ZONING COMMITTEE STAFF REPORT

FILE # 18-117-556

1. **APPLICANT:** Rehder And Associates on behalf of Twin Cities German Immersion School
 2. **TYPE OF APPLICATION:** Site Plan Review **HEARING DATE:** 12/20/2018

- A. **PURPOSE:** Site Plan for a 3-story, 23,500 square foot building addition to an existing school, play area and stormwater management. The proposed site plan includes removal of a portion of the existing building and east surface parking lot on the site.

SITE DEMOLITION PLAN

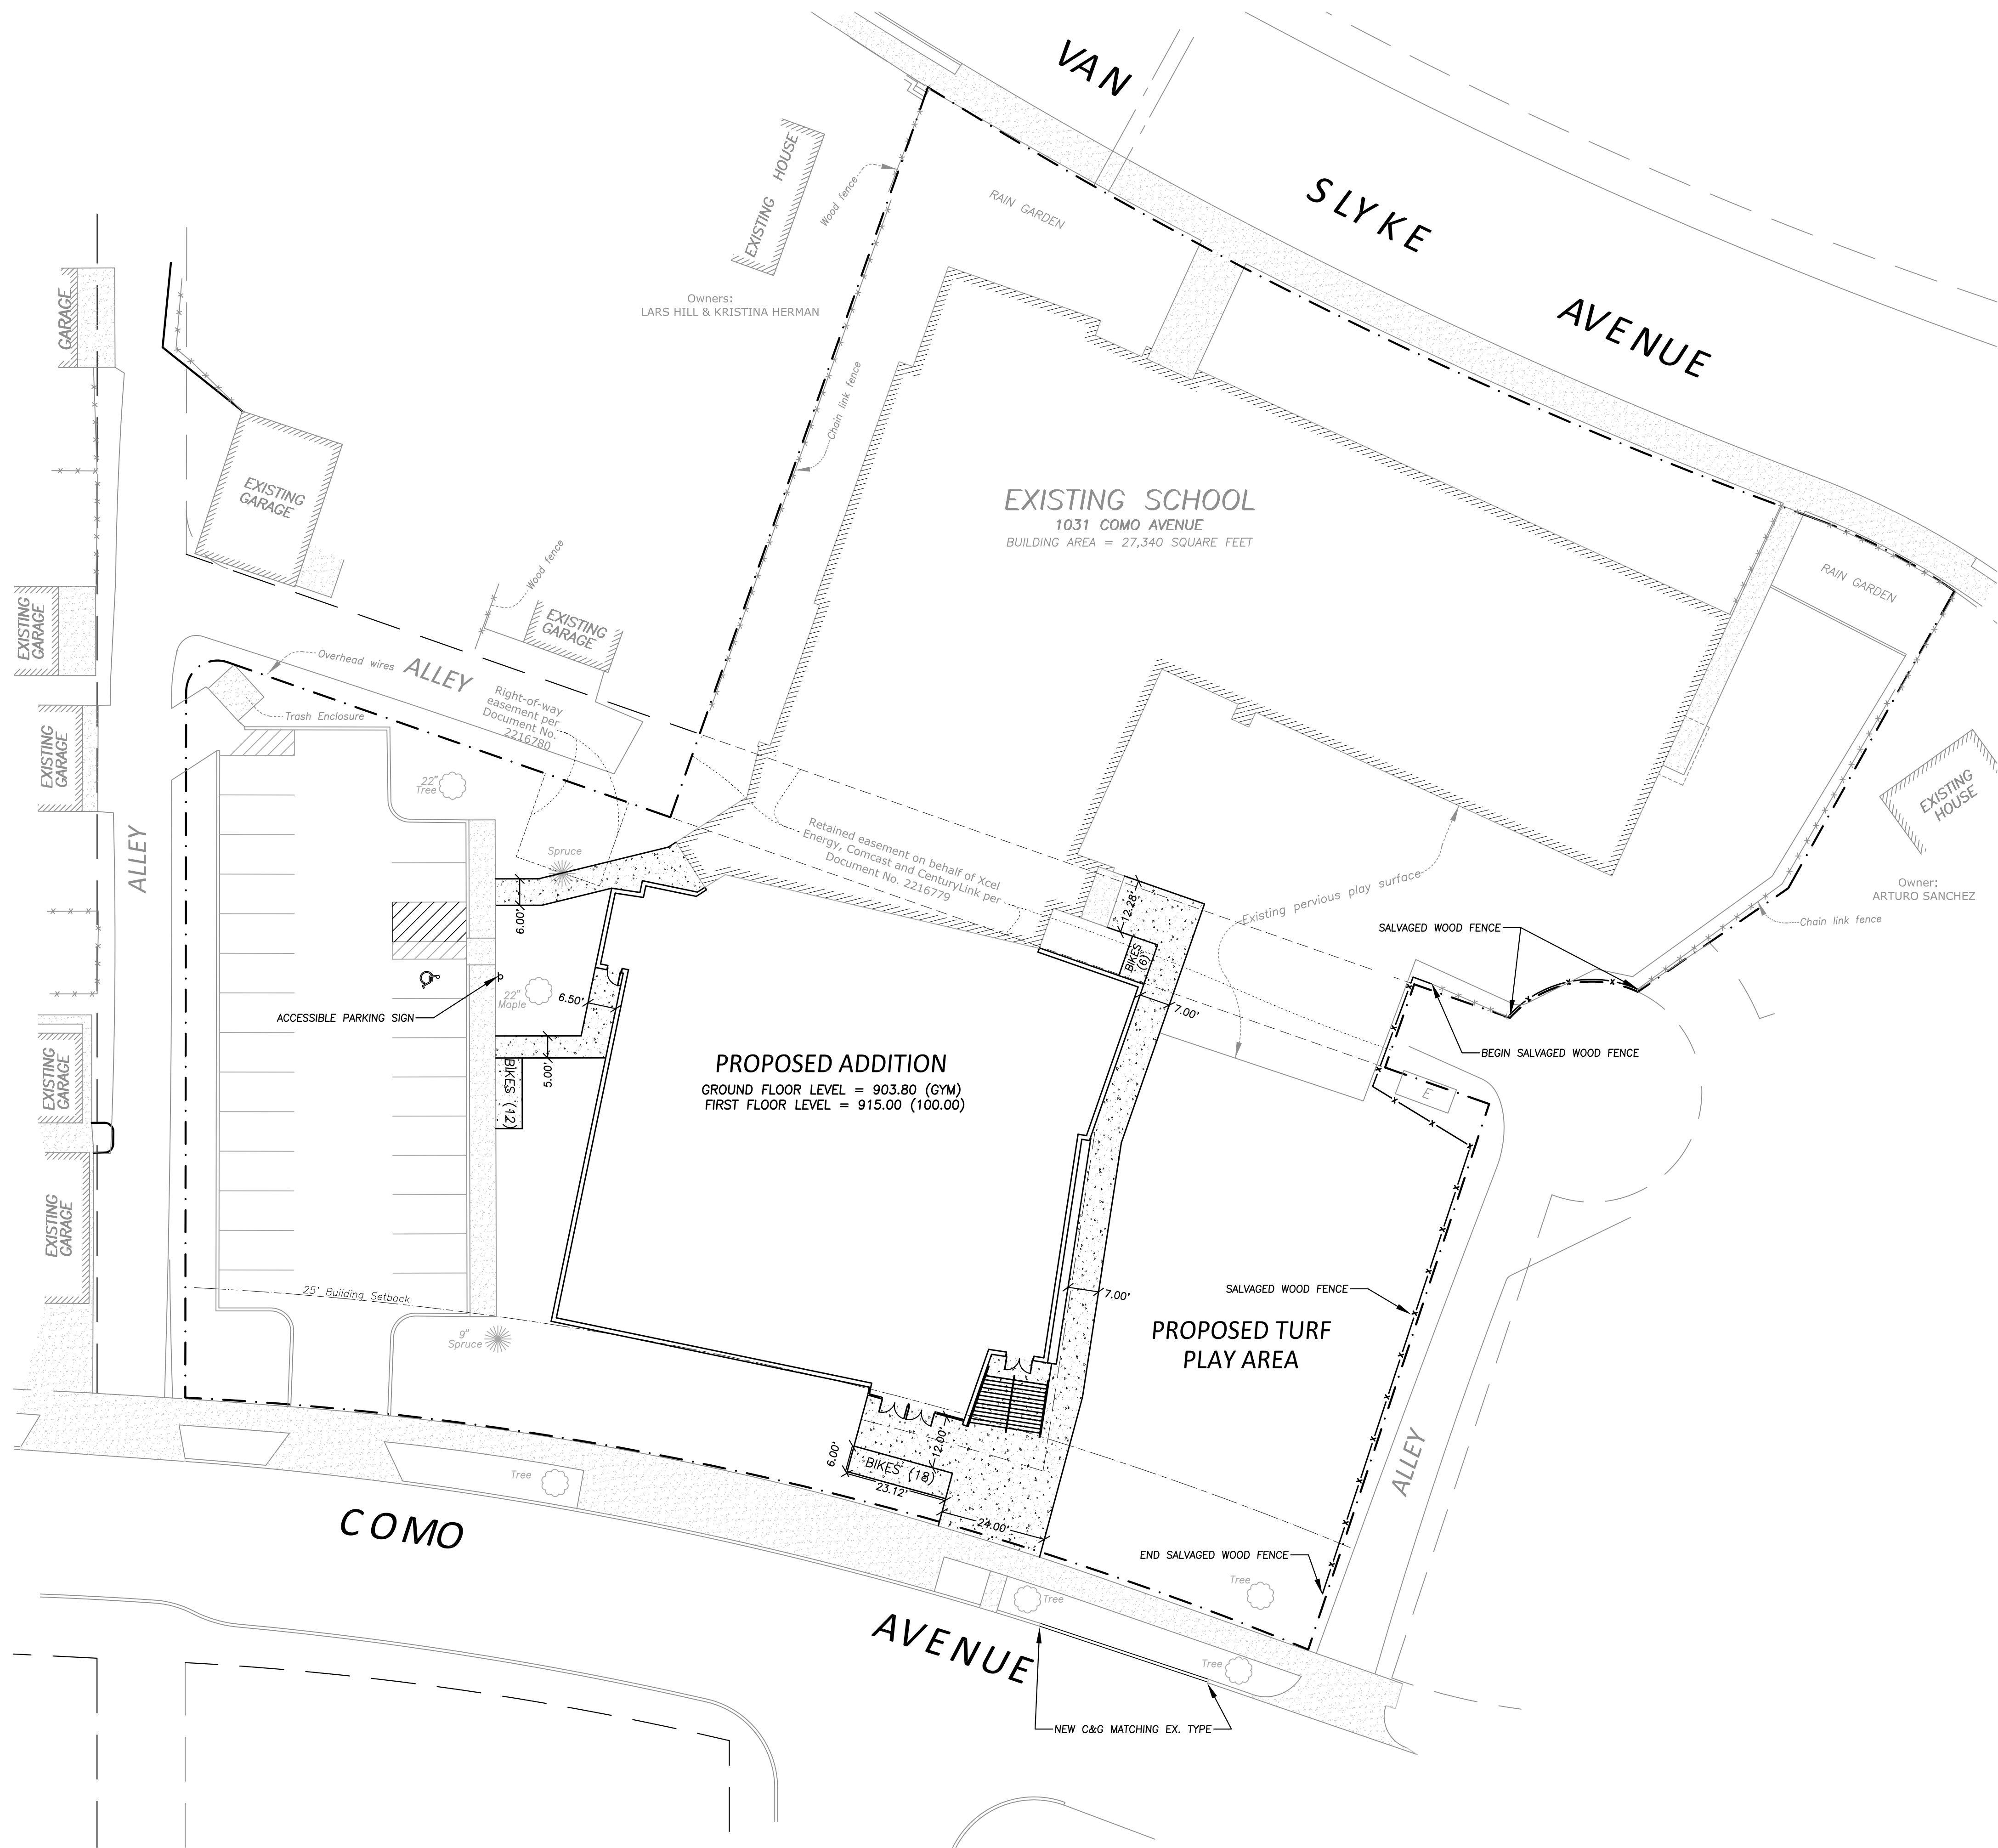
- d) Please remove any encroachments of private property onto public rights-of-way and update the Removal Plan Sheet C0 accordingly. The Survey plan sheet shows a fence encroaching into the alley east of the property.

- f) On Plan Sheet C0, please show removal of the outwalk adjacent to the driveway proposed for removal.
- g) Please provide a traffic impact study of the existing conditions and proposed improvements. Please contact David Kuebler at 651.266.6217 with questions regarding the study.

- a) Existing street trees are to be protected at all times. Trees damaged or removed during construction shall be restored or replaced to the satisfaction of, and at no cost to, the City as determined by the Forestry manager.
- b) Sheet C0: Demo Plan
 - Tree protection fencing is required around the existing street trees on Como Avenue. Show this on the plan sheet and include a tree protection fence detail in the plan set.
 - Along with demolition note one, all base materials under pavements in the boulevard area are to be removed.
- c) Sheet L1: Landscape Plan
 - One new street tree is required where the driveway is removed on Como Avenue. Tree to be a New Horizon Elm, 2.5" caliper
 - Update the tree planting detail to include the following notes:

- d) Please remove any encroachments of private property onto public rights-of-way and update the Removal Plan Sheet C0 accordingly. The Survey plan sheet shows a fence encroaching into the alley east of the property.

- f) On Plan Sheet C0, please show removal of the outwalk adjacent to the driveway proposed for removal.

9. On Plan Sheet C0, please show removal of the outwalk adjacent to the driveway proposed for removal.
10. Staff is reviewing the updated Traffic Impact Study received on Dec 11, 2018. Any comments will be forthcoming in a separate communication.

- b) Sheet C0: Demo Plan
 - Tree protection fencing is required around the existing street trees on Como Avenue. Show this on the plan sheet and include a tree protection fence detail in the plan set.
A tree protection detail 7/C3 was added. Silt fence is also shown around the three trees on sheet C0 near Como Avenue.

- Along with demolition note one, all base materials under pavements in the boulevard area are to be removed.
This note was added to sheet C0.
- c) Sheet L1: Landscape Plan

GRADING & EROSION CONTROL PLAN
TWIN CITIES GERMAN IMMERSION SCHOOL
IMMERSION SCHOOL
CITY OF ST. PAUL

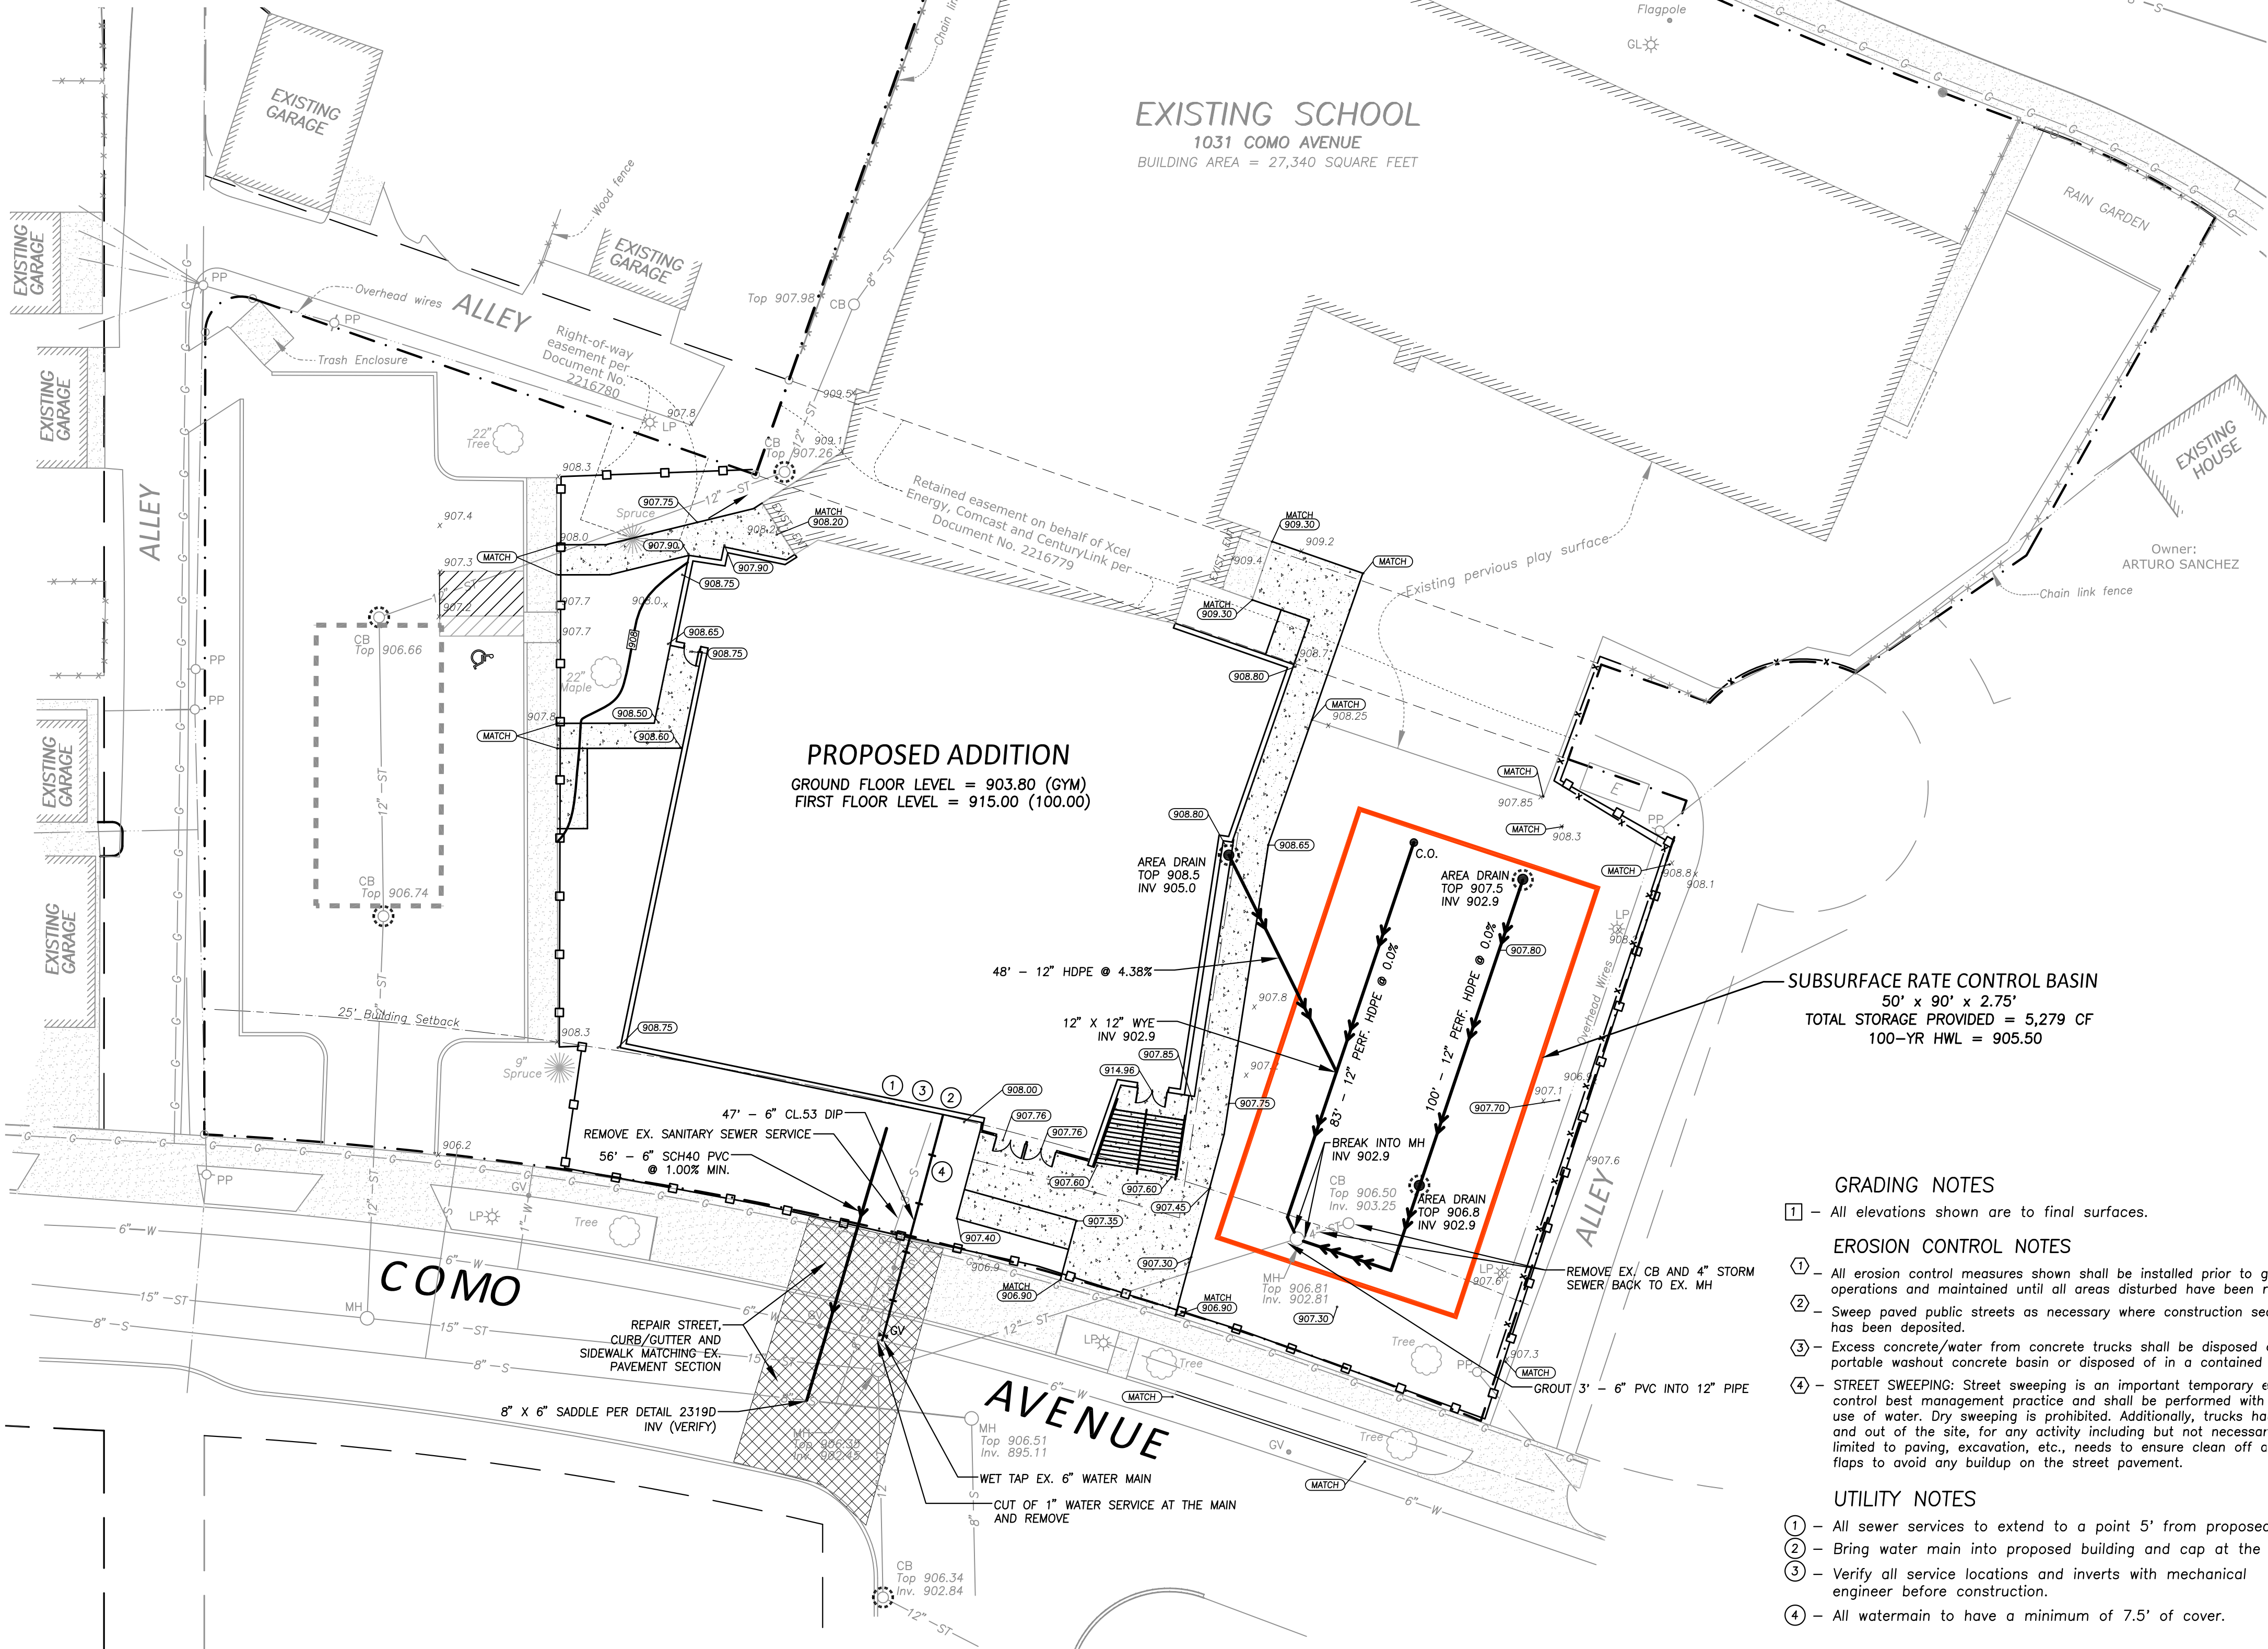
The site plan meets this finding. The utility connections are shown on Sheet C2. Water, Sanitary and Storm sewer services are available in Como Avenue.

These notes were added to sheet C2.

These two notes were added to sheet C2.

These two notes were added to sheet C2.

These five notes were added to sheet C2.

This note was added to sheet C2.

These two notes were also added to sheet C2.

These two notes were added to sheet C2.
